MASTER DRAINAGE PLAN

DRENNAN INDUSTRIAL CENTER

SUBJECT: Drennan Industrial Center, Filing No. 1  
Drainage Revision

SUBJECT: Drennan Industrial Center Filing Number One  
Drainage Revision

PROPOSED CONCRETE DRAINAGE APRON.  
 5-4-82

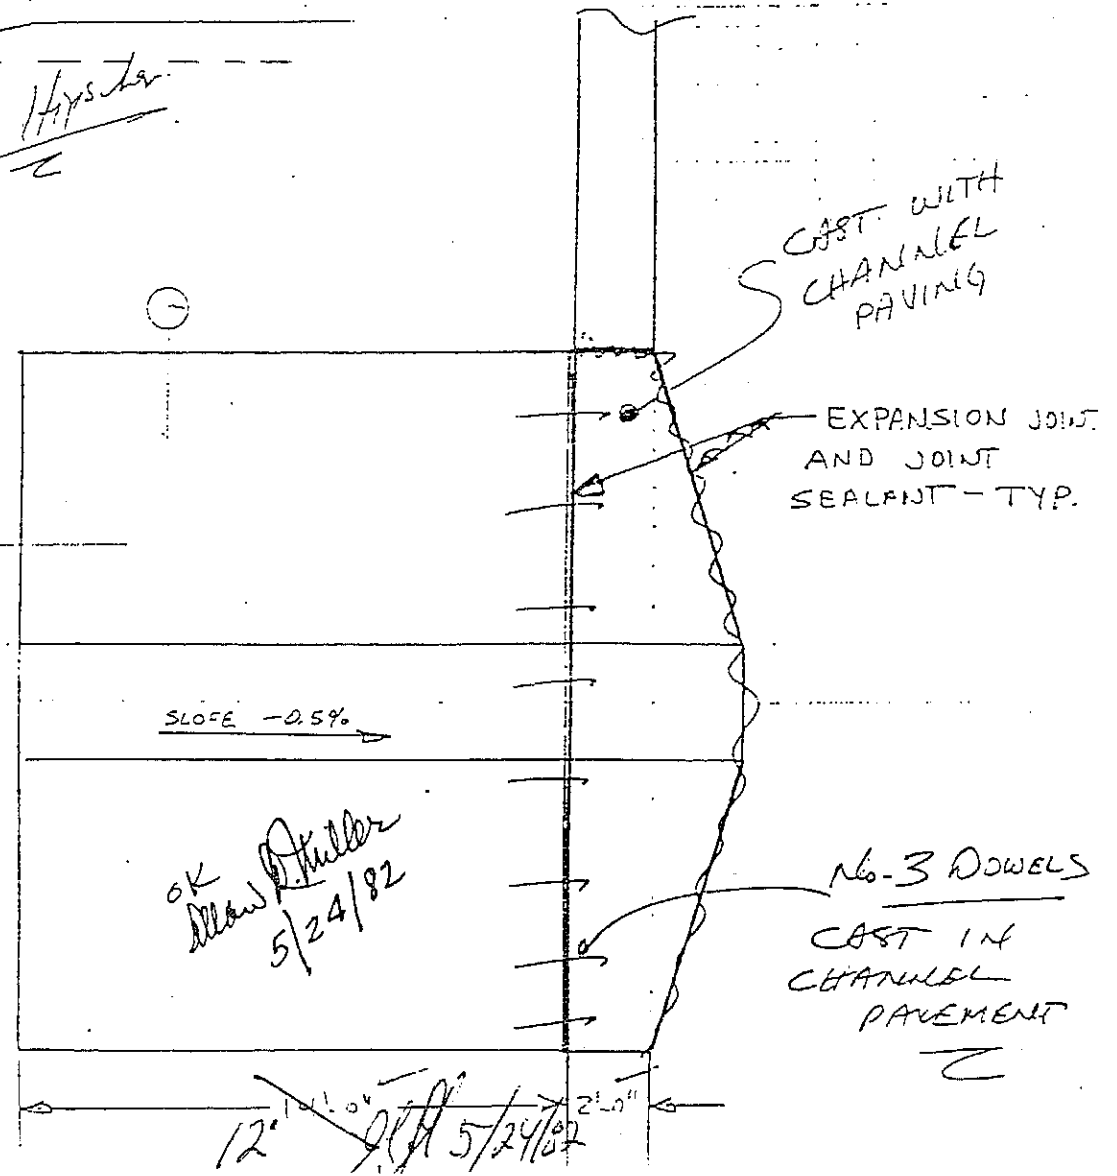
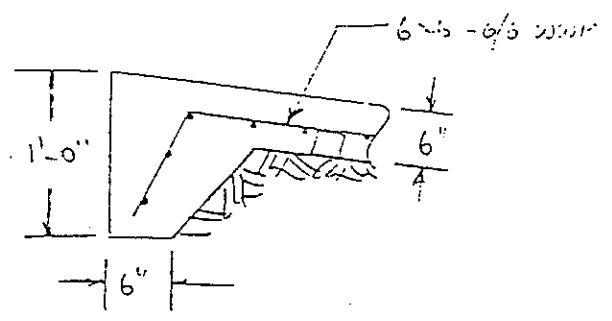
The inlet is to be a 6-inch thick reinforced concrete trapezoidal section, B=8', Z=12:1, D=1'-0", to extend a minimum of 10 feet behind the lip of the channel lining, and to have a minimum one-foot cutoff collar placed all around the termination. I understand that the channel lining has been placed and a blackout provided to conform to this configuration.

*12*  
*OK*  
*5/24/82*  
*see attached*  
*drawings*  
*for detail*  
*section &*  
*Plan.*

This configuration agreed with Hyster  
 to with stream - Mr. Will Hyster  
 See work site report

OK  
 Alan R. Miller  
 5/24/82

OK  
 5/24/82
